Overview

The purpose of this notification is to advise customers of a product marking change for Virtex®-6 FPGA packages. There is no change to the form, fit, or function.

Description

Product marking example:

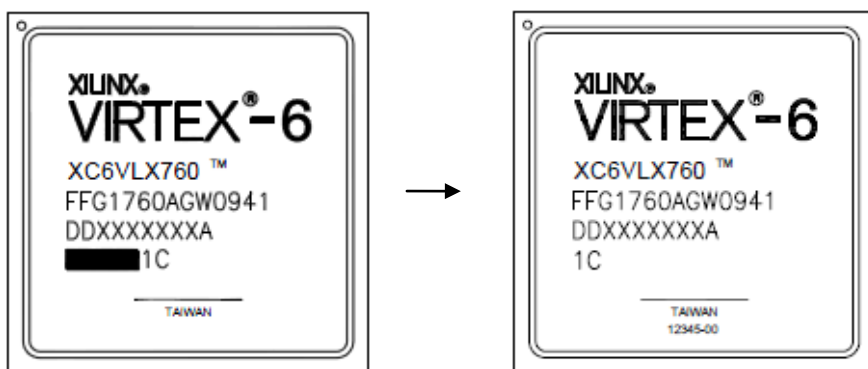
Xilinx will be converting the package top mark from ink mark to laser mark and adding a device trace code for all Virtex-6 FPGA Flip Chip packages.

Current Marking (Black Ink)

New Marking (Laser)
